**REPORT ON PLANT
FOR BAKERSFIELD, KERN RIVER VALLEY, KING
CITY, SALINAS, SELMA AND VISALIA DISTRICTS**

**California Water Service Company
Test Year 2017 General Rate Case
A.15-07-015**

**San Francisco, California
March 2016**

Figure 2-A: LOW Zone Maximum Day Demand⁹

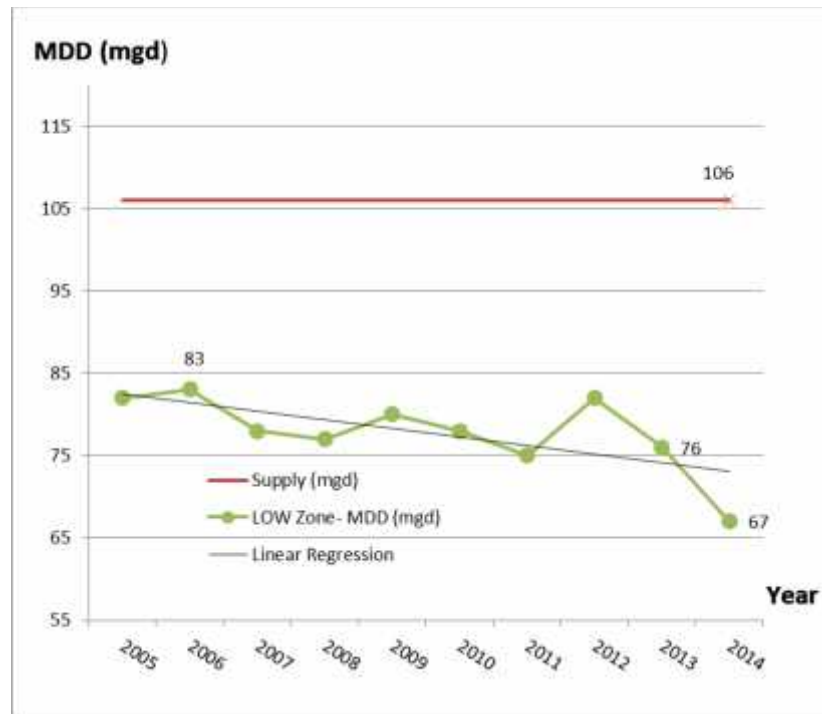
Based upon the information provided, the highest MDD in the LOW Zone between 2005 and 2014 is 83 mgd from year 2006. The MDD in this zone has never reached the 120 mgd level between 2005 and 2014 that CWS claimed in its project justification (PJ) Report. The current supply of 106 mgd exceeds the highest historical MDD of 83 mgd in the LOW Zone. Moreover, as shown in **Figure 2-A** below, water demand has decreased in recent years to 67 mgd in 2014.

Figure 2-C: Wired and Wireless Security Cameras

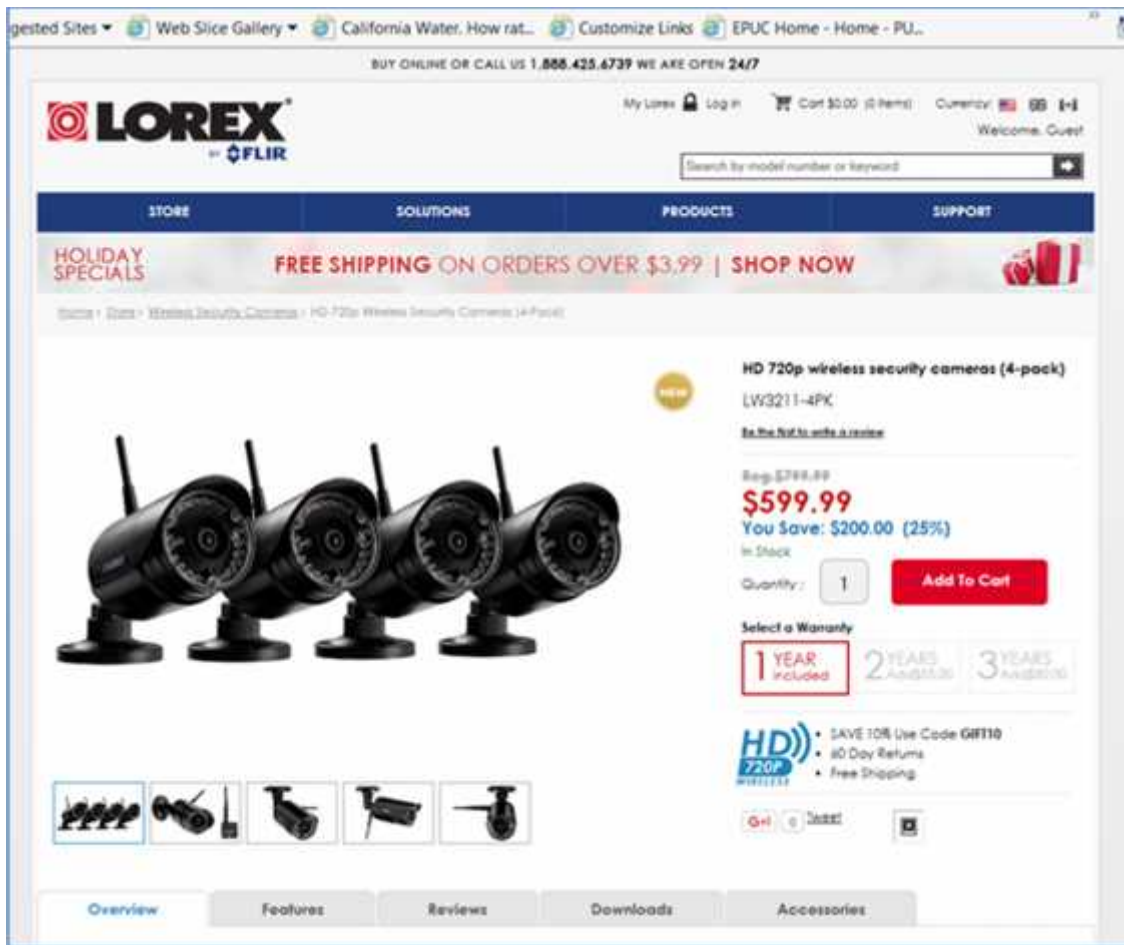
(RWPP) for \$123,852 in 2016.⁸² CWS stated that the current security cameras provide poor resolution. In addition, these cameras are no longer manufactured and they are unreliable and unmaintainable. The RWPP does not have any type of security, and for this reason, CWS requests to upgrade its cameras in the Northeast treatment plant facility and add cameras at the RWPP.⁸³

Figure 3-A: 2005 to 2015 MDD trend in Kernville System¹⁵⁰

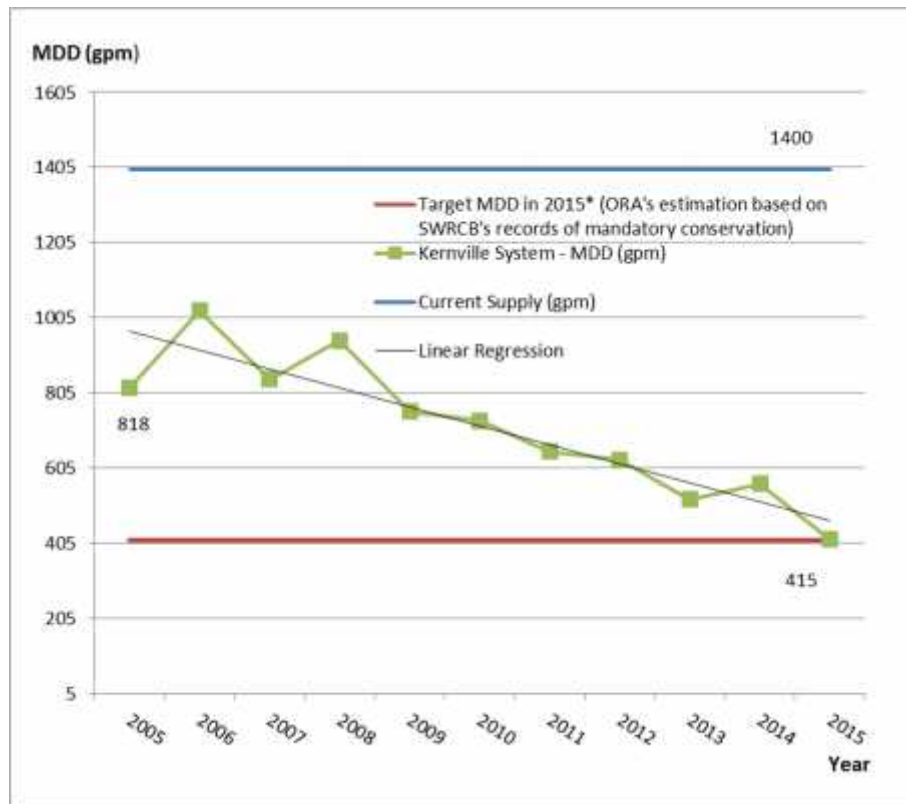
8 The Kernville SWTP produces enough water to meet customers' usage in the system. In
9 a 2013 annual inspection report for the Kernville System, the State Water Resources
10 Control Board's Department of Drinking Water Program (DDW) stated that the source
11 capacity (1,400 gpm) exceeds the maximum day demand (MDD) of 361 gpm. ¹⁴⁶ In its
12 response to ORA's data requests, CWS provides the MDD data of the Kernville system.
13 **Table 3-G** and **Figure 3-A** show the 2005 to 2015 MDD for the system. ¹⁴⁷ The 2015
14 MDD is ORA's estimated data based on the governor's mandatory reduction. ¹⁴⁸ This
15 decreasing demand is consistent with CWS's conservation efforts and need to meet the
16 SB 7x7 conservation goal for 2020.

Figure 5-A: Zone 280's Recorded MDD²²⁴

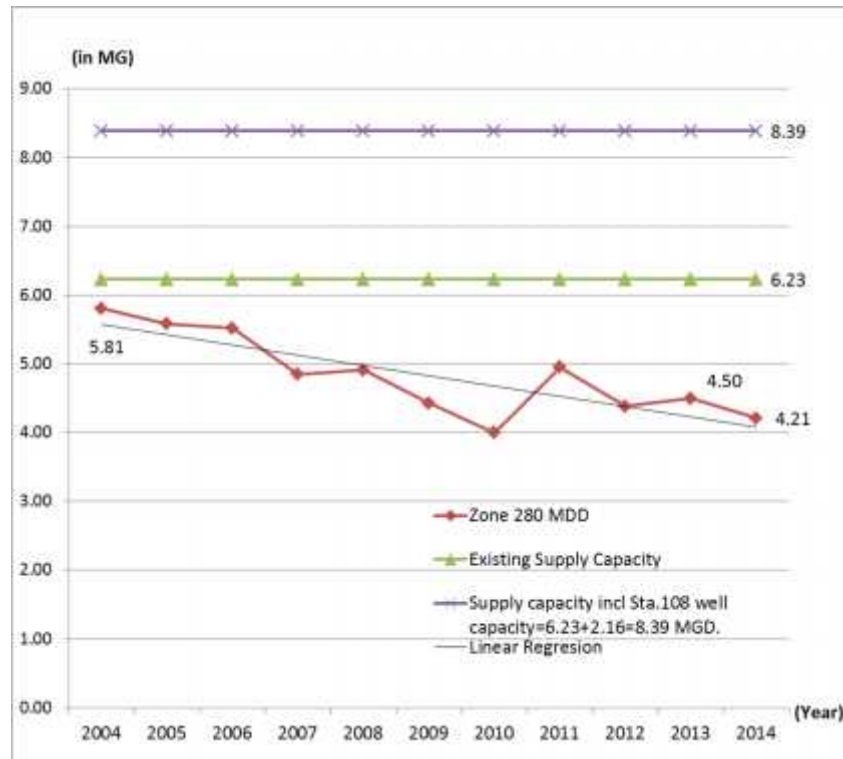
12 In its Zone 280 supply-demand analysis, CWS's use of the 2004 MDD of 5.81MGD ²²³
13 significantly overstates the expected demand for this zone. **Figure 5-A** below shows
14 Zone 280's recorded MDDs and the declining trend.

Figure 5-B: Zone 155's Recorded MDD²³⁶

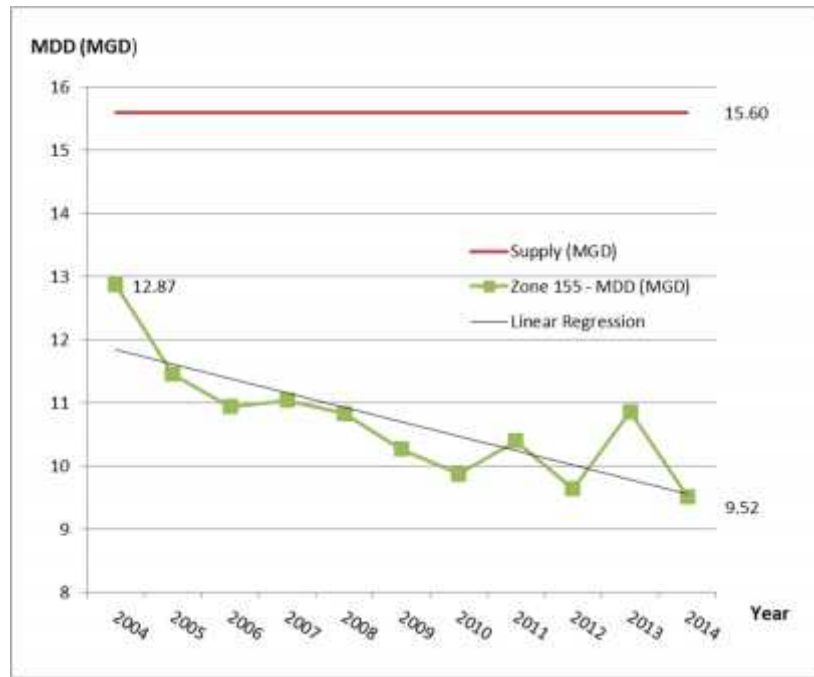
Similar to the decreasing trend of customer demand occurring in Zone 280 (PID 99286), **Figure 5-B** below shows Zone 155's recorded MDD and the declining trend.

As shown above, Zone 155's MDD has been steadily decreasing, from 12.87 MGD in 2004 to 9.52 MGD²³⁷ in 2014, a total of reduction of 26%.²³⁸ This decreasing demand is

Figure 5-C: Supply and Recorded MDD²⁹³ in Country Meadows System

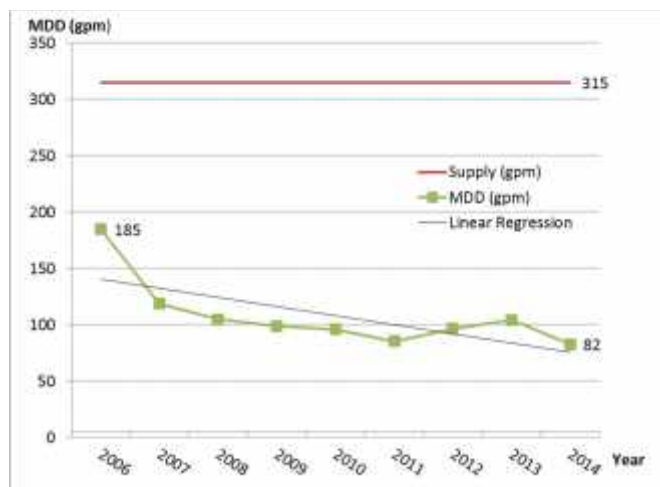
17 **Figure 5-C** below shows the MDD and available supply capacity in the Country
18 Meadows System between 2006 and 2014.

The MDD used in CWS's supply-demand analysis is from 2006.²⁹⁴ CWS failed to note that demand has decreased significantly since then. CWS's MDD is outdated and does not reflect the significant downward trend in consumption due to the implementation of conservation programs and the recent drought mandates to reduce consumption. In 2014, the MDD of the system has declined to 82 gpm, or approximately 44%²⁹⁵ of the 2006 level. The highest MDD since 2006 occurred in 2013, at only 104 gpm, and can serve as an approximation of the expected demand in the supply-demand analysis. This 104 gpm MDD can be met by the smallest existing well (110 gpm capacity) at Station 60. As

17 In sum, CWS's claimed supply deficiency in the Country Meadows System relies on an
18 inflated MDD that is not representative of recent or expected demand, and
19 inappropriately discounted available supply. There is no MDD or PHD deficit in this
20 system. As shown in [Figure 5-C](#) above, the existing supply in the Country Meadows
